Historic Review

9712 SE Cambridge Lane, Milwaukie, Oregon 97222

ADDITION FOR
 MARIE & GREG LATHROP
 9712 SE CAMBRIDGE LANE
 MILWAUKIE, OREGON 97222

Sheet Title:
 SECTIONS
 AT BATH

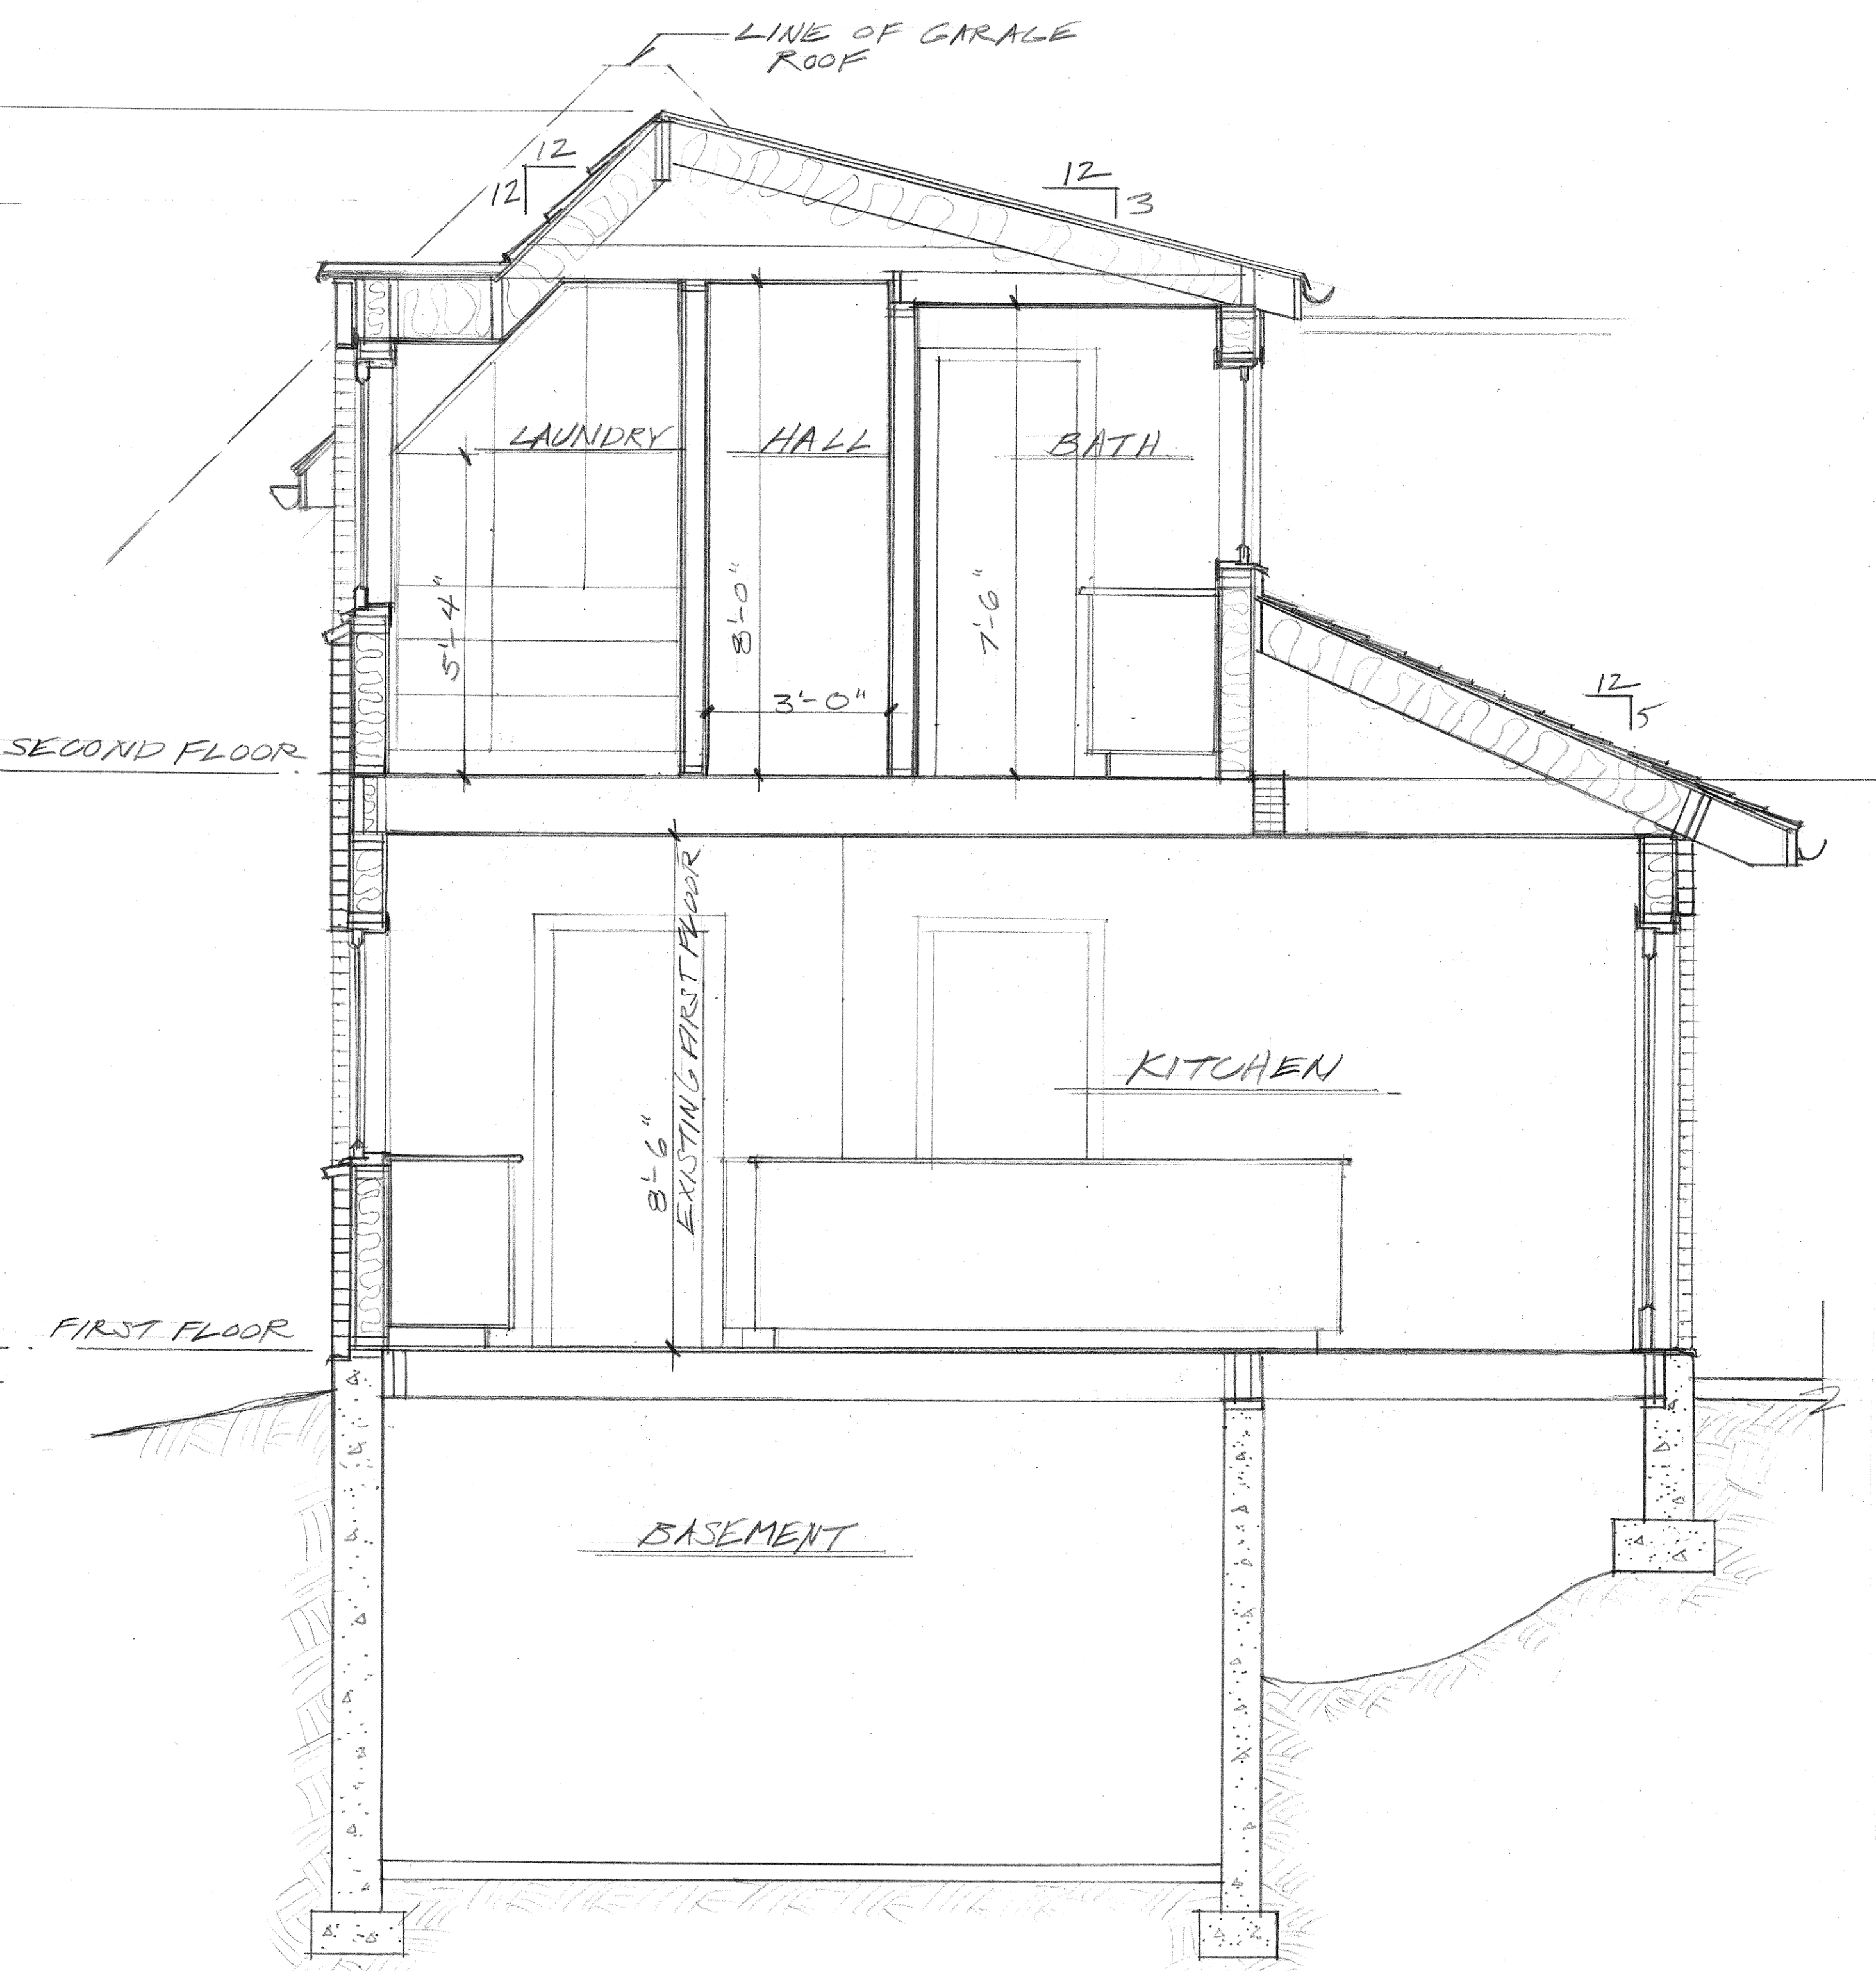
The consultant suggests that the roof height of the addition be no higher than the existing roofs of the service wing and garage while also retaining the 12:12 roof pitch. This is geometrically impossible as the footprint of each is larger than the respective existing footprint. The point of this application is to receive permission to enlarge the house while complying with the criteria in Section 19.403.5 in the Milwaukie Zoning Code. The overall maximum building height is maintained as are the current floor to floor heights. The garage floor is lowered 21" to better fit the site and minimize the height of the garage.

The current service wing has lower ceilings than the rest of the house both upstairs and on the main floor. The enlarged kitchen will match the ceiling height on the main floor. The upstairs back hall and bath does not meet current codes for ceiling height or insulation. It also has a lower ceiling height than the rest of the second floor. Once these spaces are altered, they must be brought up to code. I have added a detailed section to compare the existing and new volumes. Dormers, shed roofs, and reduced ceiling height in the new bath were used to keep the overall roof heights as low as possible.
